Rebuttal evidence – Vehicle Access and Highway Safety

Land North of A507 and West of Buntingford

Project Name:	Land North of A507 and West of Buntingford
Project Ref:	23161
Report Title:	Rebuttal Evidence – Vehicle Access and Highway Safety
Date:	25.08.26
Report Ref:	23161-RIDGE-XX-XX-AP-H-0002_P03
Client:	Hallam Land Management

Figure 4.1: Hertfordshire County Council design of Jarman access crossing as produced on the 28th November 2025 (extracted from Drawing number ITP240008-1 – GA – 1 of 3)

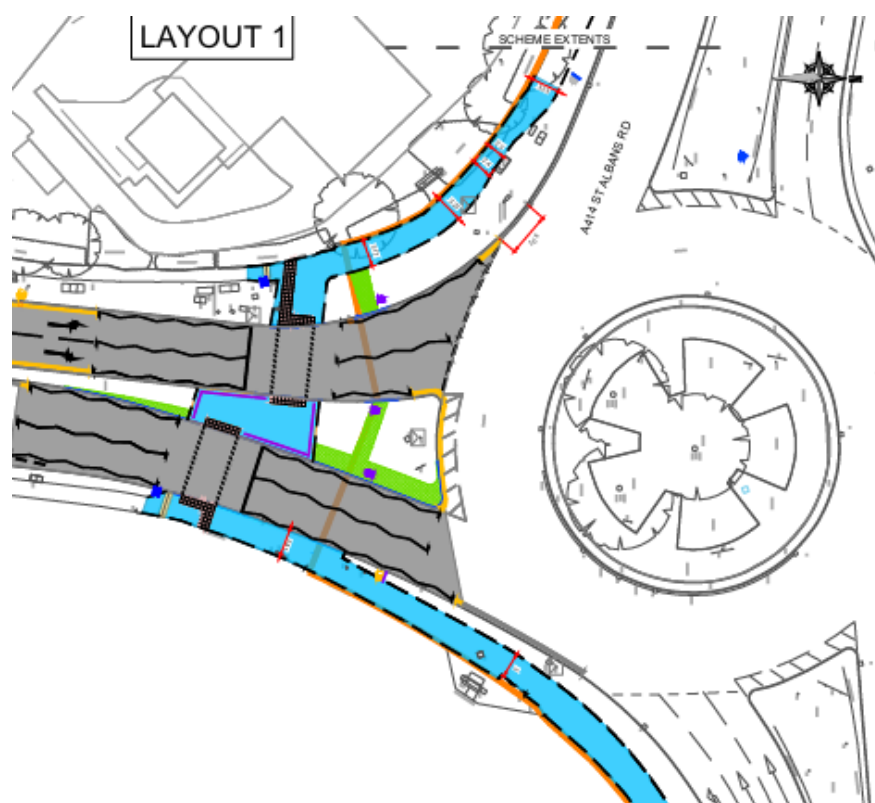
4.2.1 Ms Carpenter has queried the approach of introducing a stagger at the proposed at grade crossing and has referred to non-staggered solutions and LTN 1/20 guidance. I consider however that, in this location, a stagger would provide a more appropriate option as it would allow increased refuge area between the northbound and southbound movements. This allows users to wait/rest which is of particular importance for those less mobile and those with children. In addition, the distance between the crossings at 9m would not add significantly to walk/cycling distances.

4.2.3 I would also point to the fact that a staggered crossing is a common solution that continues to be implemented as an effective and safe strategy for connection. For example, a recent staggered crossing junction has been implemented by HCC, and opened in June 2026, at the access to Jarman Park, in Hemel Hempstead, and I extract the original drawing for these proposals as **Figure 4.1** which is also included as **Appendix B** of my rebuttal. In addition, a location plan (as extracted from HCC's web site) for this crossing is also shown in **Figure 4.2** below.

Figure 4.5: Extract of alternative crossing design to show available highway land (shown as orange line) around crossing area that would provide margin for changes to the design at detailed design stage if required

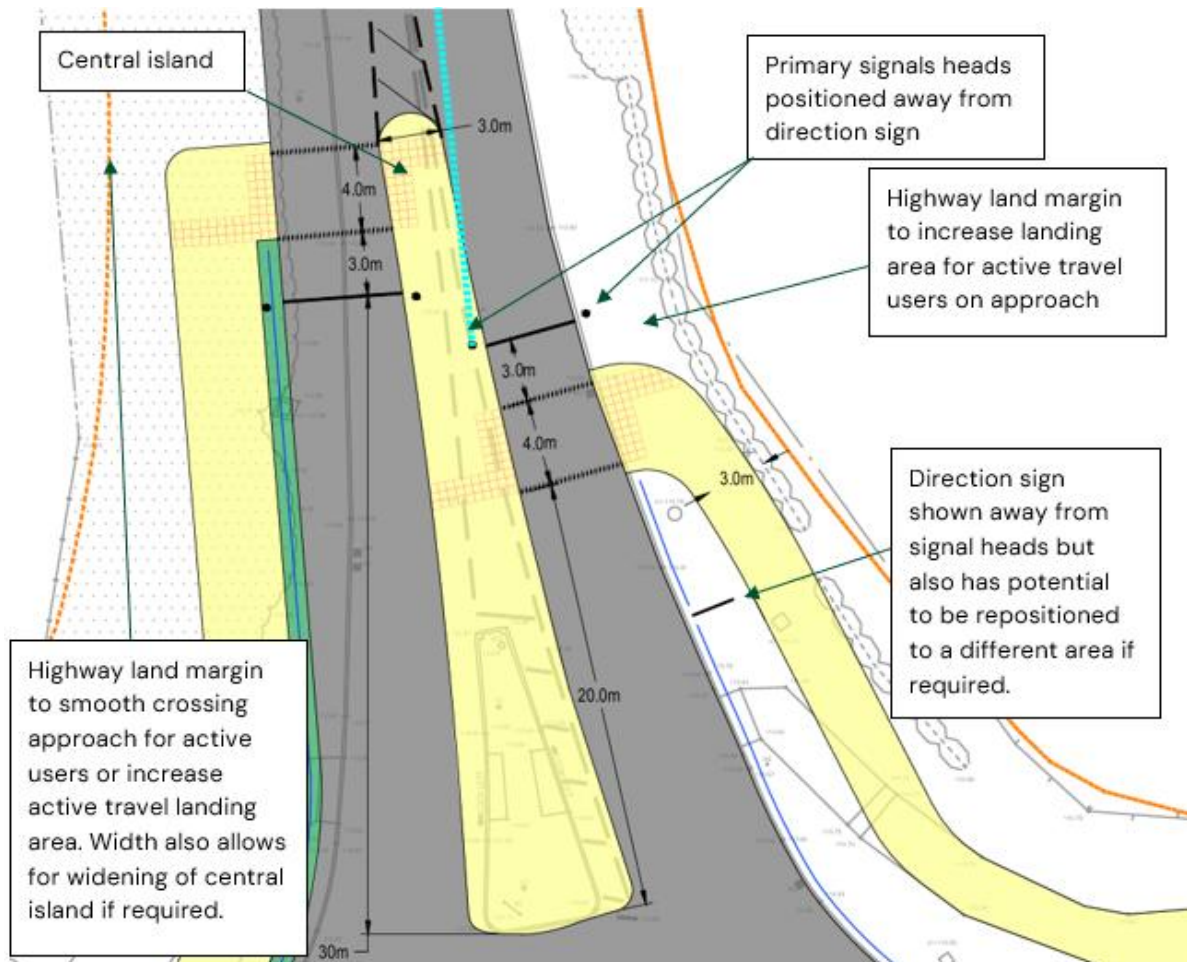
- 4.7.1 Whilst Ms Carpenter has not mentioned concerns as to the width of the crossing central island in the main body of their PoE there is brief reference to this in the conclusion. To note the width of the central island is at minimum 3m for both the original design (Appendix G of my PoE) and the alternative setback option (Appendix X of my PoE). To note this minimum width is similar to that provided at the Jarman crossing. Notwithstanding this, as I have previously set out, significant highway land is available either side of the crossing which can be used to further widen this if required (see again reference to this in **Figure 4.5** below which marks this on the alternative design although equally relevant to the original proposals).

- 4.8.1 Ms Carpenter has stated that an existing direction sign on the A10 close to the entrance of the Baldock Road roundabout would obscure the traffic signals on approach. I note however that there is highway land available to position primary signals at a number of locations including the central island or move the direction sign itself if required. I also note that the alternative crossing design (extract in **Figure 4.5** below) is also set back further from the sign so the stop line / infrastructure would be in advance of this.
- 4.8.2 I consider this again a detailed point that is easily addressed as part of detailed design as would be expected in the design development for this type of proposal.
